SERVICE BULLETIN

MITSUBISHI MOTORS

PURPOSE : CHANGE	ISSUE NO. : MSB-14EXML15_17-001	DATE : 2014-10-02
SUBJECT : Omission of N mark for non-reusable parts and the tightening torque in the exhaust related parts.		<DESTINATION/MODEL> <M/Y> (For all destinations) As per attached sheet 1
GROUP : Gr:15(Intake exhaust)/Gr:17(Emission control)

<4G6>

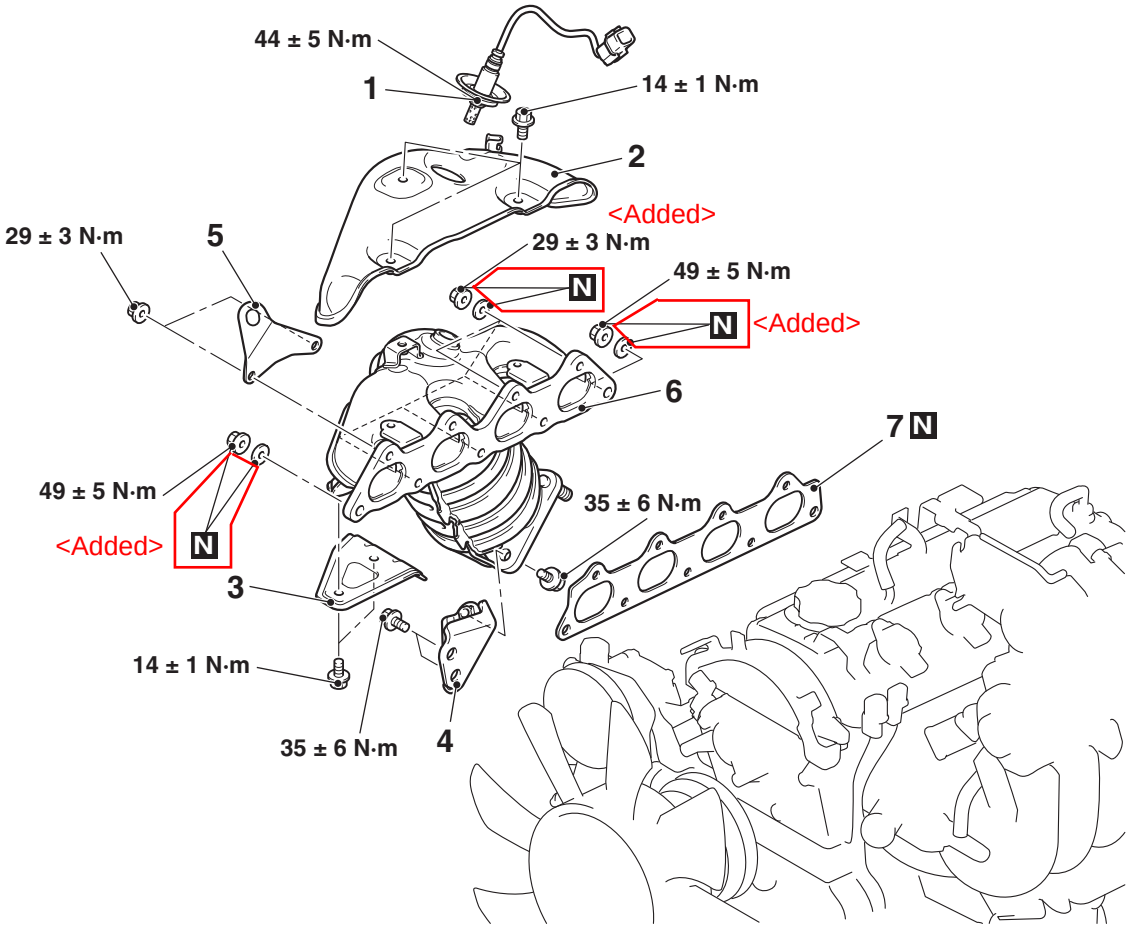
44 ± 5 N·m
1
14 ± 1 N·m
2
<Added>
29 ± 3 N·m
5
29 ± 3 N·m
N
49 ± 5 N·m
N
<Added>
6
7 N
49 ± 5 N·m
<Added>
N
35 ± 6 N·m
3
14 ± 1 N·m
35 ± 6 N·m
4

<6G7>

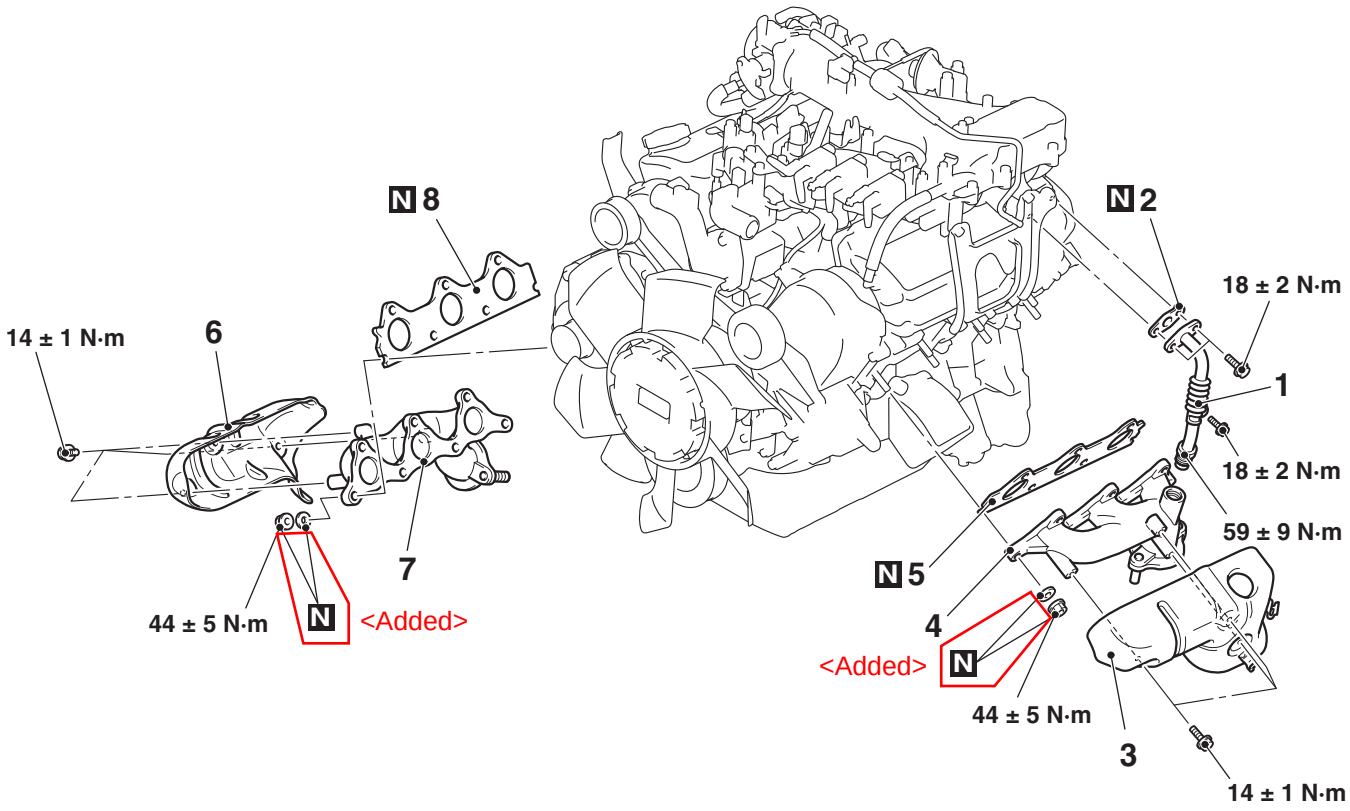
N 8
N 2
18 ± 2 N·m
14 ± 1 N·m
6
1
18 ± 2 N·m
59 ± 9 N·m
N 5
7
4
44 ± 5 N·m
N
<Added>
<Added>
N
44 ± 5 N·m
3
14 ± 1 N·m

<4G6>

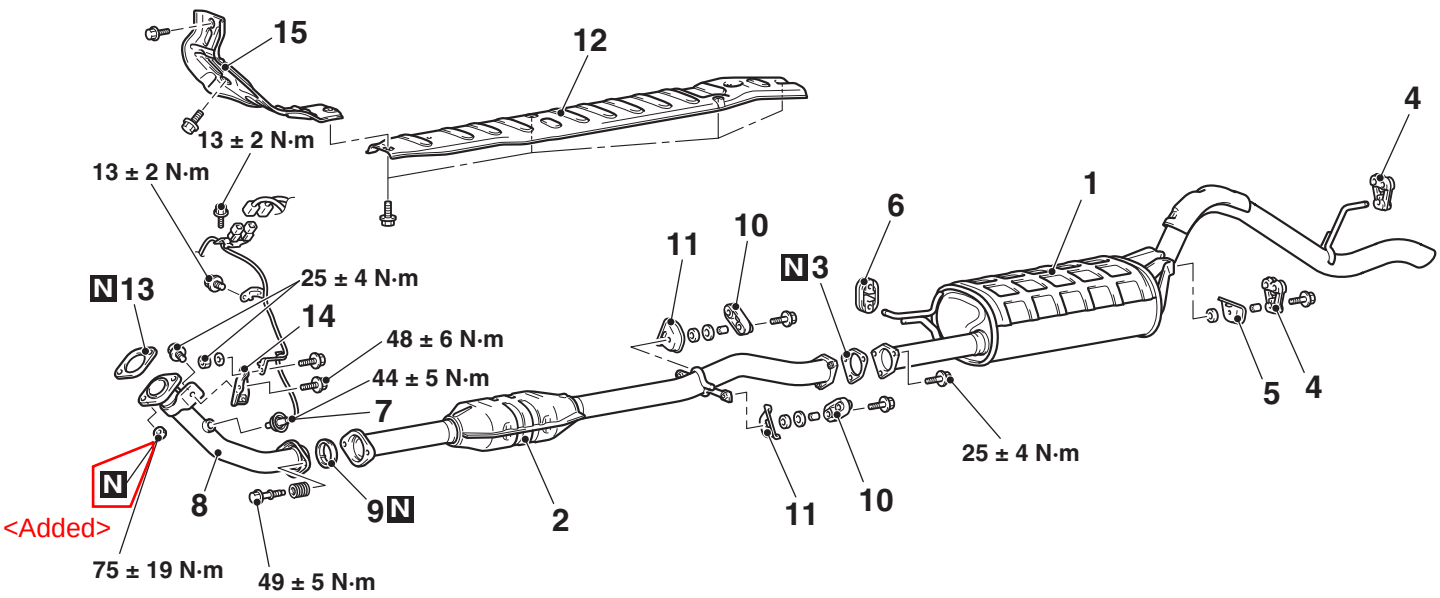
15
12
13 ± 2 N·m
13 ± 2 N·m
4
1
6
11
10
N 3
N 13
25 ± 4 N·m
14
48 ± 6 N·m
44 ± 5 N·m
7
5
4
25 ± 4 N·m
N
8
9 N
2
11
10
<Added>
75 ± 19 N·m
49 ± 5 N·m

<6G7>

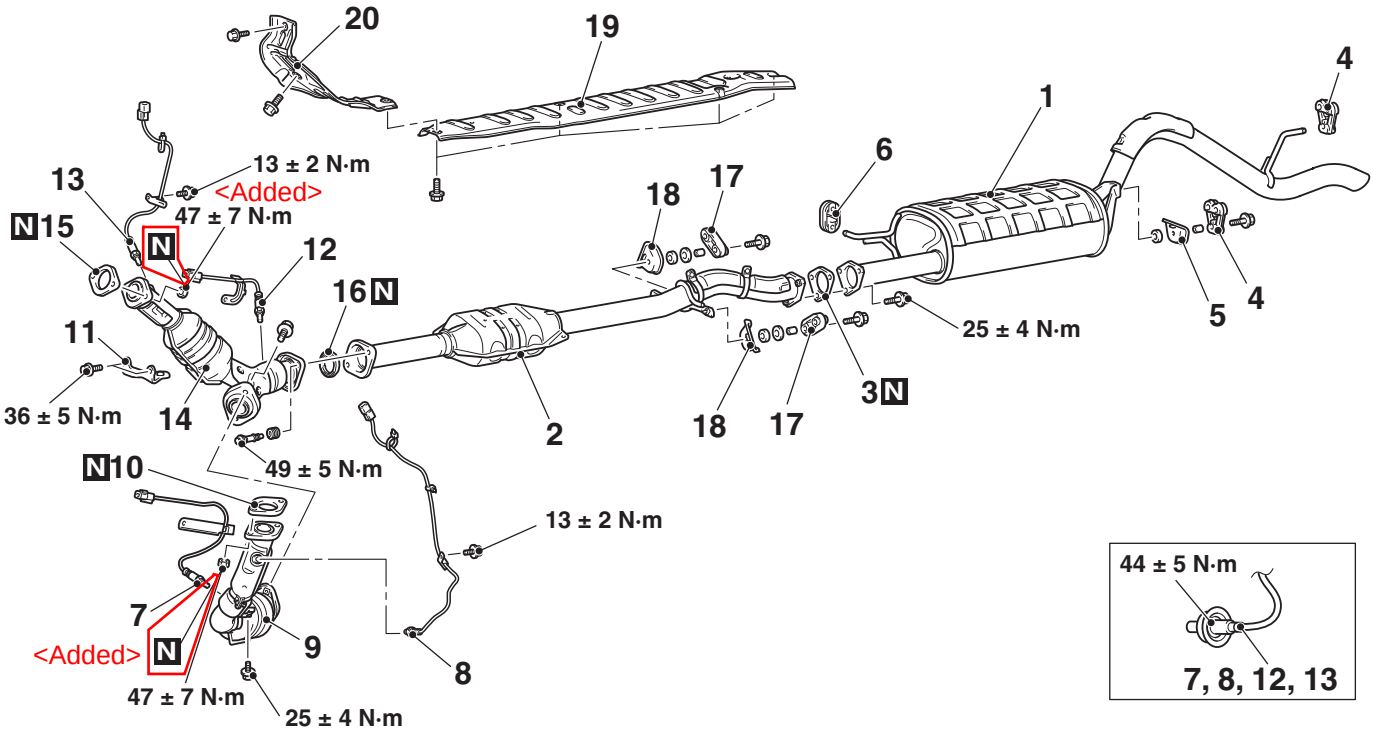
20
19
4
1
6
13
13 ± 2 N·m
<Added>
47 ± 7 N·m
N 15
N
12
18
17
16 N
11
36 ± 5 N·m
14
2
18
17
25 ± 4 N·m
3 N
5
4
49 ± 5 N·m
N 10
13 ± 2 N·m
7
<Added>
N
9
8
47 ± 7 N·m
25 ± 4 N·m
44 ± 5 N·m
7, 8, 12, 13

<4M41>

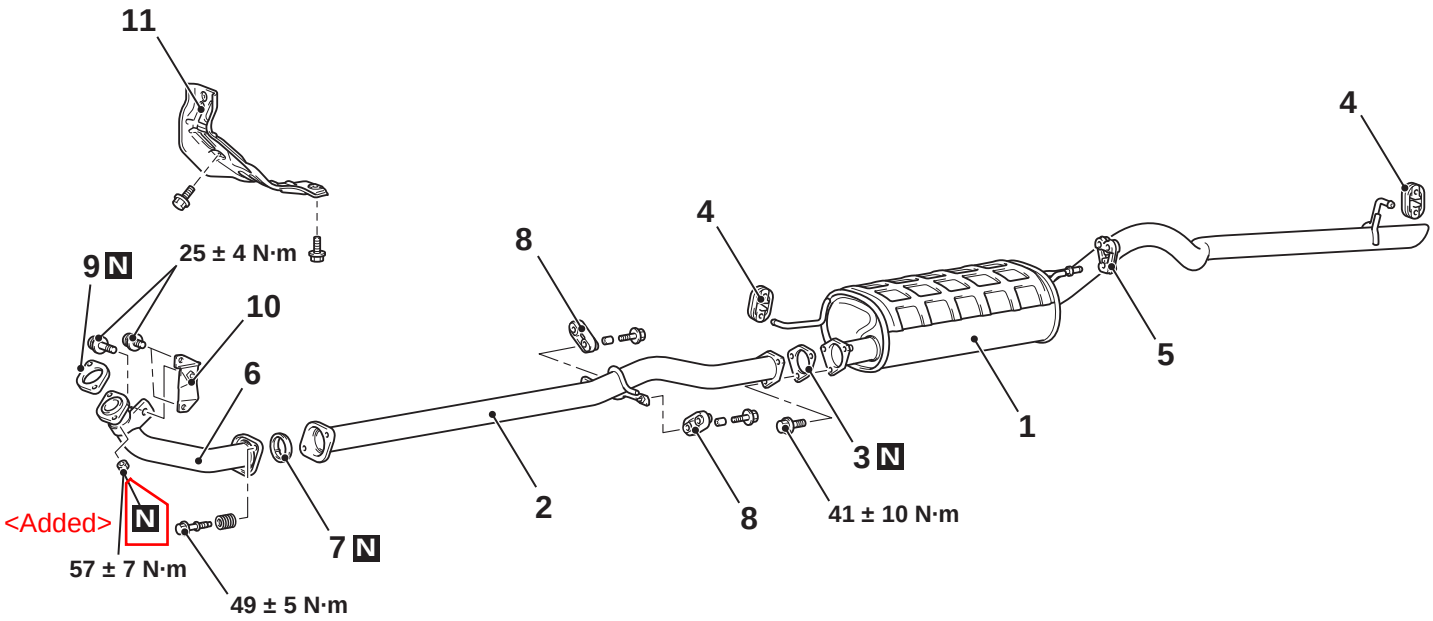
11
25 ± 4 N·m
9 N
10
6
<Added>
N
57 ± 7 N·m
49 ± 5 N·m
7 N
2
8
4
8
4
41 ± 10 N·m
3 N
1
5
AC903799AB

Attached sheet 14 (8/9)

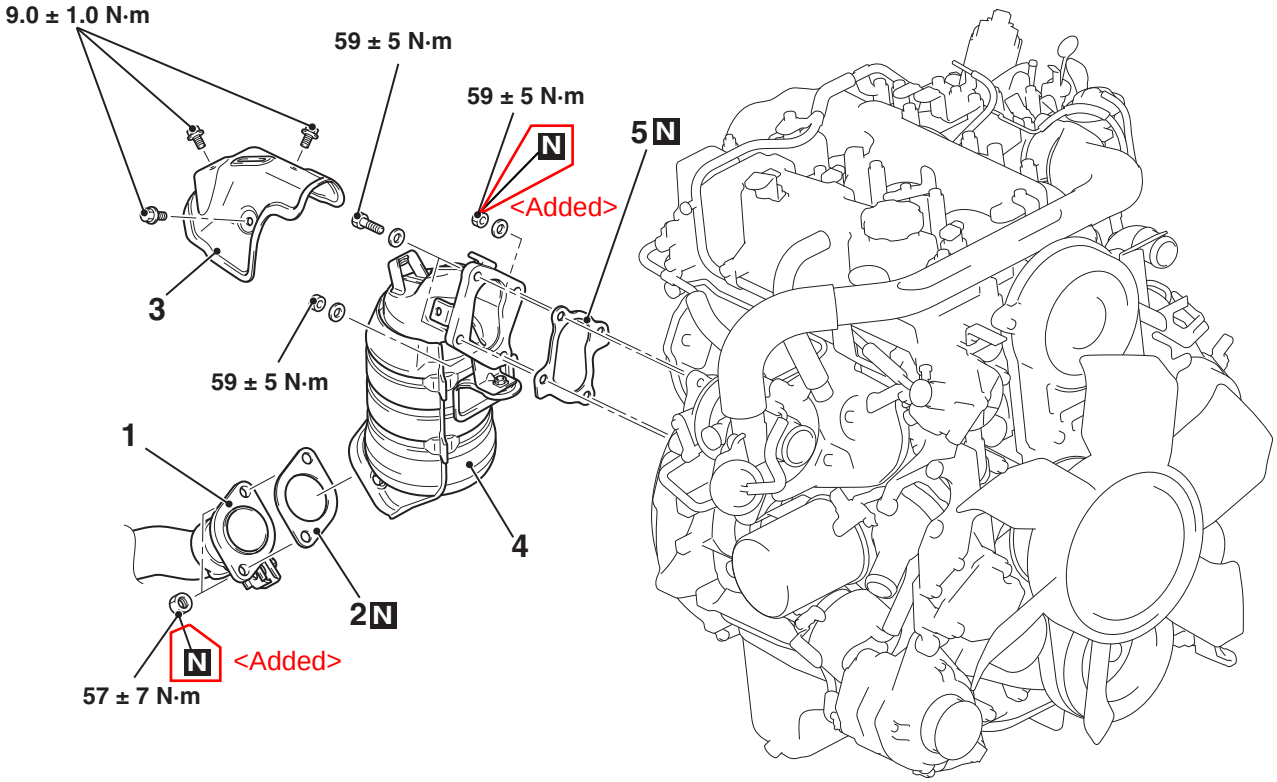
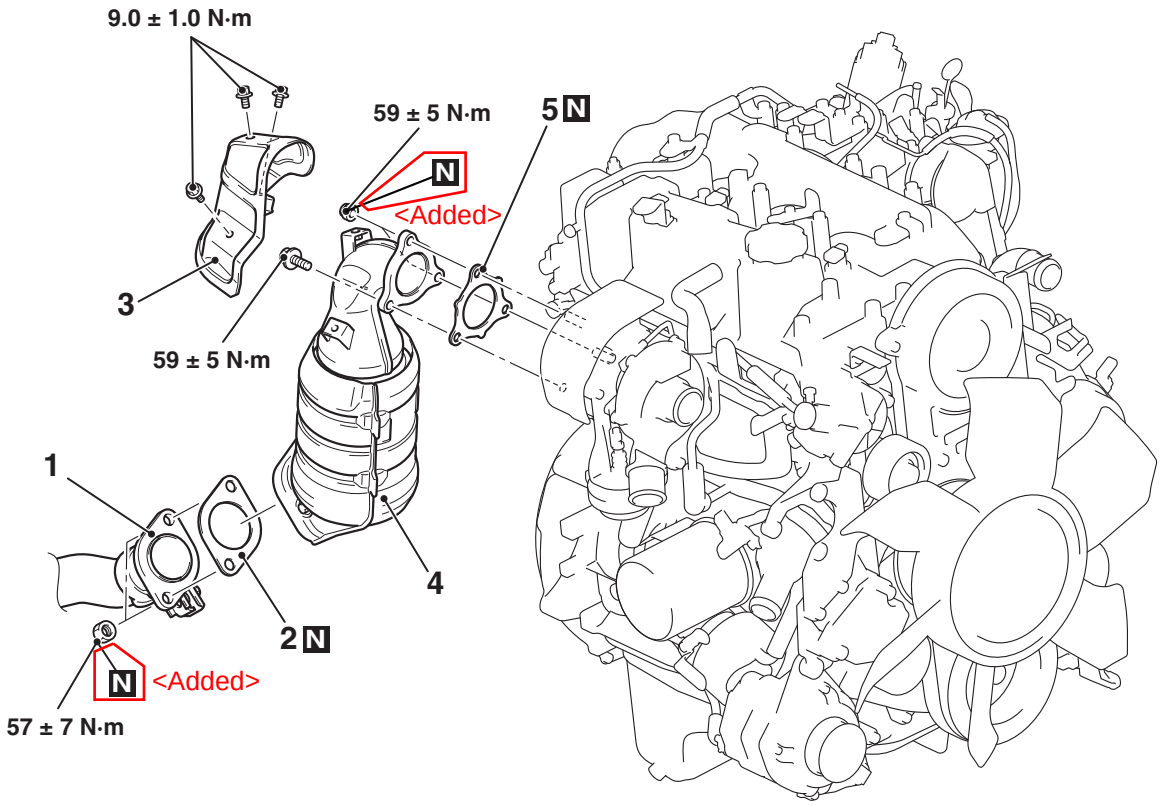
9.0 ± 1.0 N·m
59 ± 5 N·m
N
<Added>
5 N
3
59 ± 5 N·m
1
4
2 N
N
<Added>
57 ± 7 N·m

<6G72>

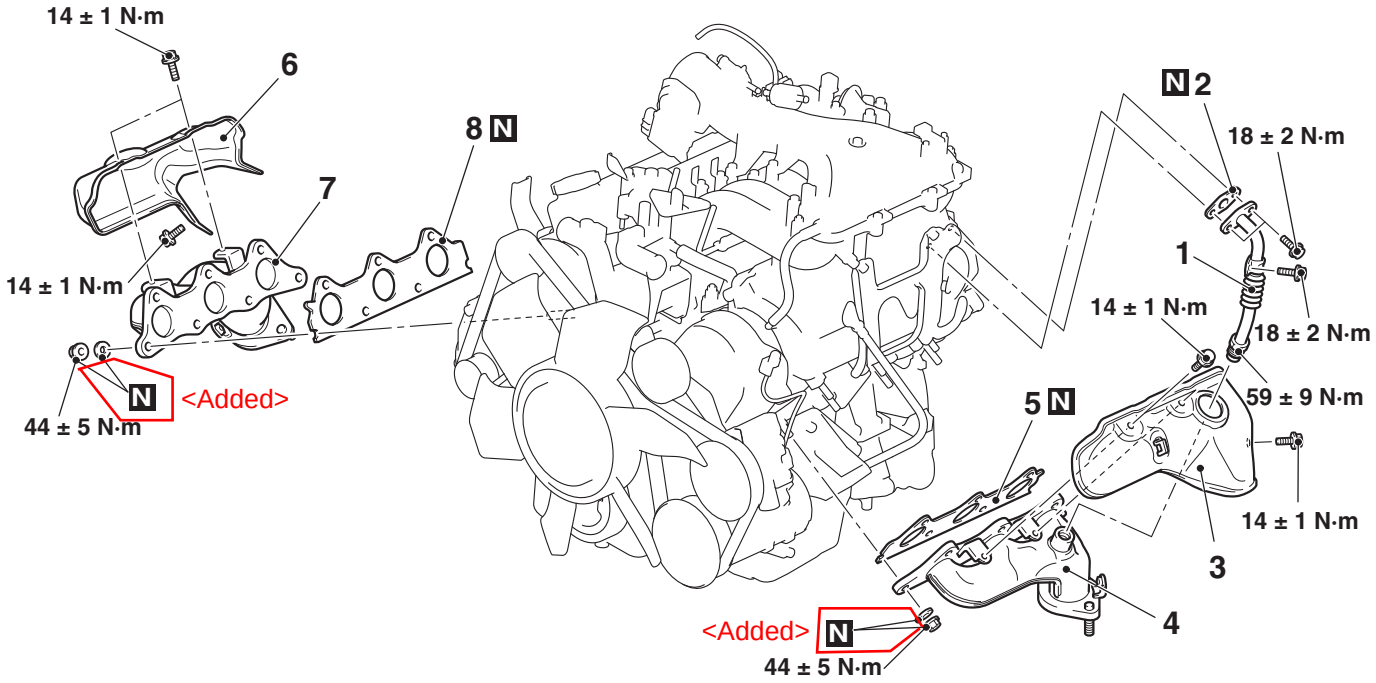
14 ± 1 N·m
6
8 N
7
14 ± 1 N·m
N
<Added>
44 ± 5 N·m
N 2
18 ± 2 N·m
1
14 ± 1 N·m
18 ± 2 N·m
59 ± 9 N·m
5 N
14 ± 1 N·m
3
4
<Added>
N
44 ± 5 N·m

<6G75>

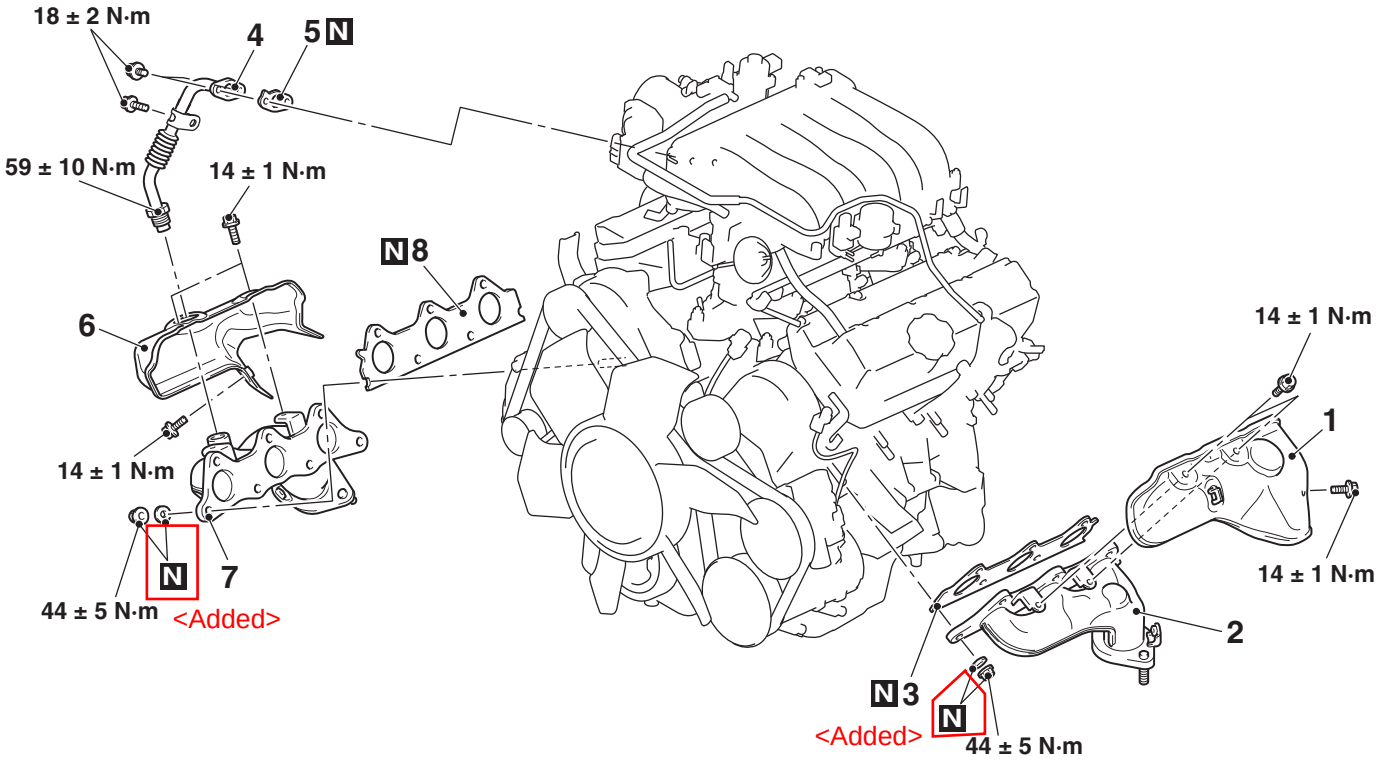
18 ± 2 N·m
4
5 N
59 ± 10 N·m
14 ± 1 N·m
N 8
6
14 ± 1 N·m
N
7
44 ± 5 N·m
<Added>
14 ± 1 N·m
1
14 ± 1 N·m
2
N 3
N
<Added>
44 ± 5 N·m

<2.0L ENGINE Turbo>

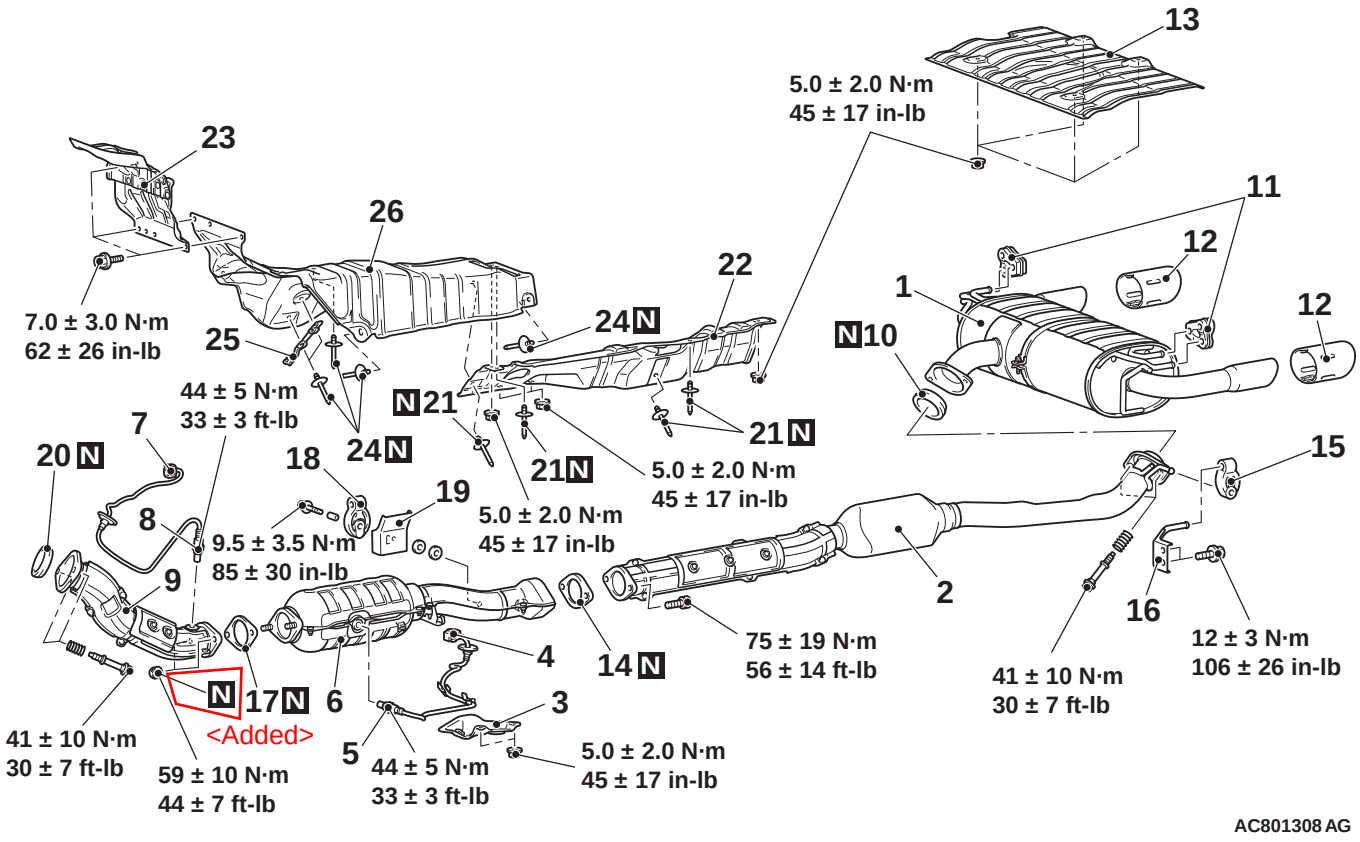
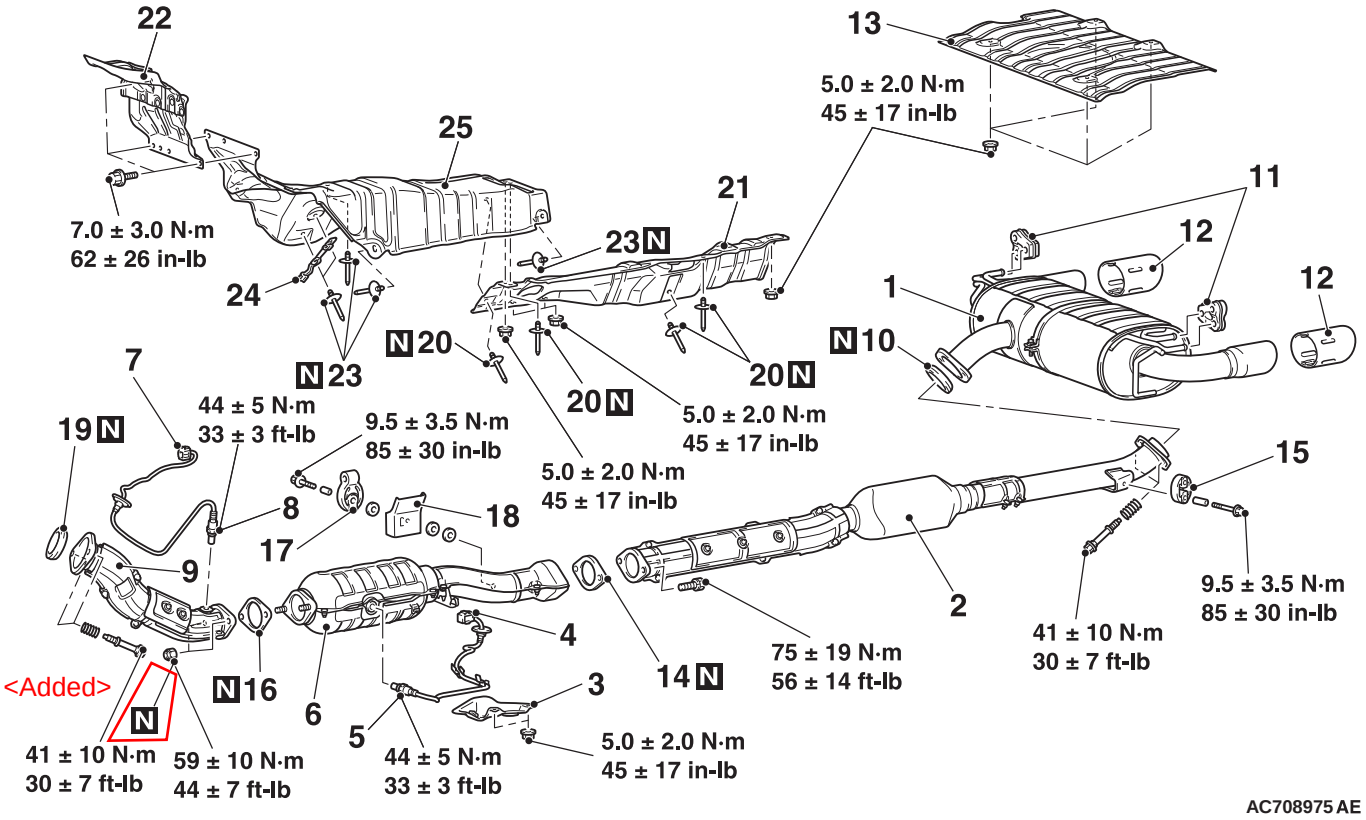
22
25
7.0 ± 3.0 N·m
62 ± 26 in-lb
24
N 23
13
5.0 ± 2.0 N·m
45 ± 17 in-lb
21
23 N
N 20
20 N
20 N
5.0 ± 2.0 N·m
45 ± 17 in-lb
5.0 ± 2.0 N·m
45 ± 17 in-lb
11
12
12
1
N 10
7
19 N
44 ± 5 N·m
33 ± 3 ft-lb
9.5 ± 3.5 N·m
85 ± 30 in-lb
8
18
17
9
15
2
9.5 ± 3.5 N·m
85 ± 30 in-lb
41 ± 10 N·m
30 ± 7 ft-lb
75 ± 19 N·m
56 ± 14 ft-lb
4
14 N
3
<Added>
N
N 16
6
5
41 ± 10 N·m
30 ± 7 ft-lb
59 ± 10 N·m
44 ± 7 ft-lb
44 ± 5 N·m
33 ± 3 ft-lb
5.0 ± 2.0 N·m
45 ± 17 in-lb
AC708975 AE
